Ford Ka with ABS built since 09/96

Problems with the radio when the ignition is switched on

Fig. 1

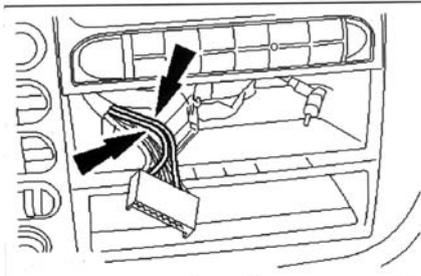
If there are complaints with these vehicles that disturbing background noise is produced by the radio when the ignition is switched on, one possible cause is that the ground cable is too long. This is disturbed by the ABS module.

- Note the radio code and remove the radio.
- At the plug for voltage and ground supply, cut off the black/yellow wire from Pin 2 and the black/green wire from Pin 6 approx. 5 cm away from the plug (Fig. 1).
- Insulate the cable ends and attach to the cable harness.
- Solder the new ground cable (brown 2.5 mm², 400 mm long) to the black/yellow and black/green cable. Insulate the solder spot.
- Remove the upper and lower steering wheel skirt.
- Lay the new ground cable from the radio plug to the cross member of the steering wheel column.
- Attach the connection eyelet (M 6) to the new ground cable.
- Fix the ground cable to the screw on the cross-member (Fig. 2).
- Install the components again in reverse order.
